Reedisha Knitex Ltd.

28 September 2013

Building Observations

Garment building: Load management

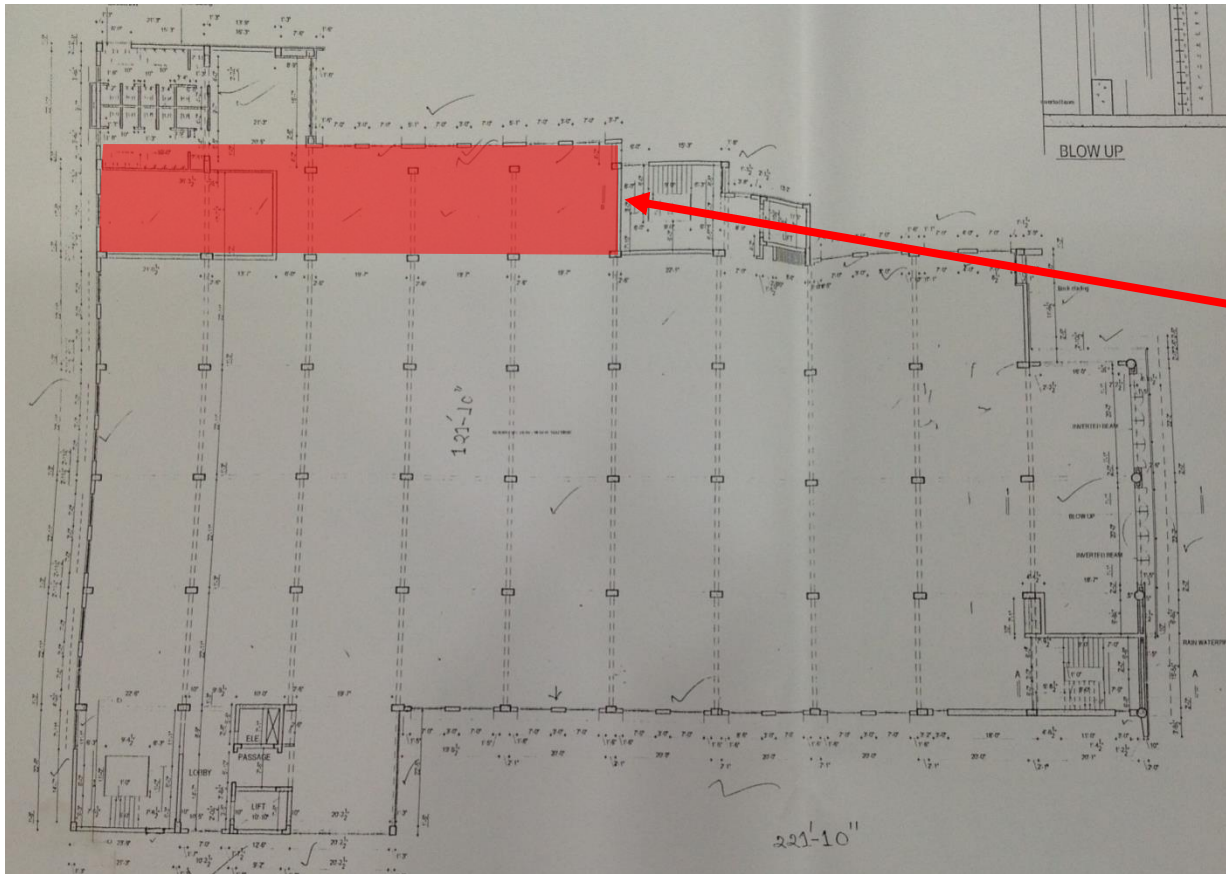
Material stacked high on 6th floor.

Plan and height restrictions to be introduced to prevent future overloading.

Restriction to be based on design floor loading.

Garment building: Check on design of roof slab regarding water tank loading

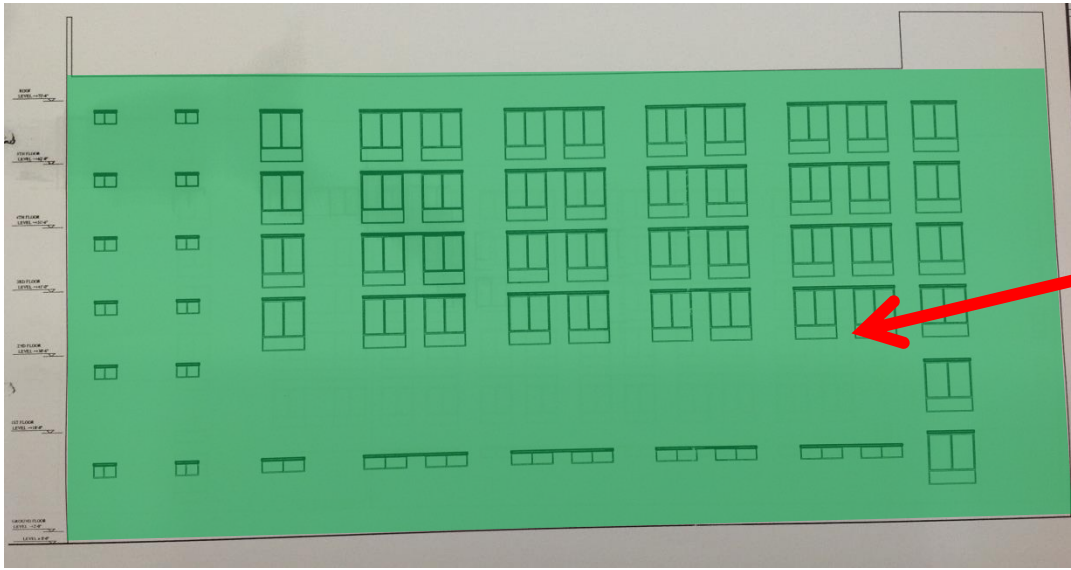
Water tanks located on roof

Garment building: Check on structure required due to additional roof extension

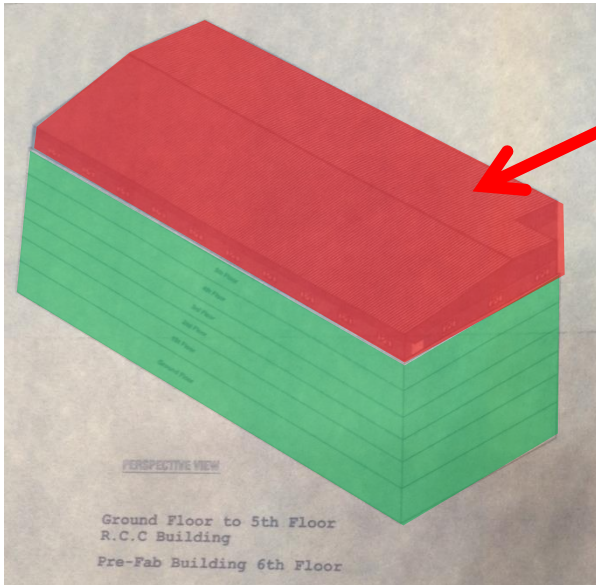
Original 6 storey permit for RC building (ground floor – 5th floor).

**Extension:
Pre-fabricated steel floor (6th floor).**

**Engineer is to perform detailed calculations to prove column sizes and (if required) :
Reduce loads by vacating floors and removing addition structures
Reinforce columns**
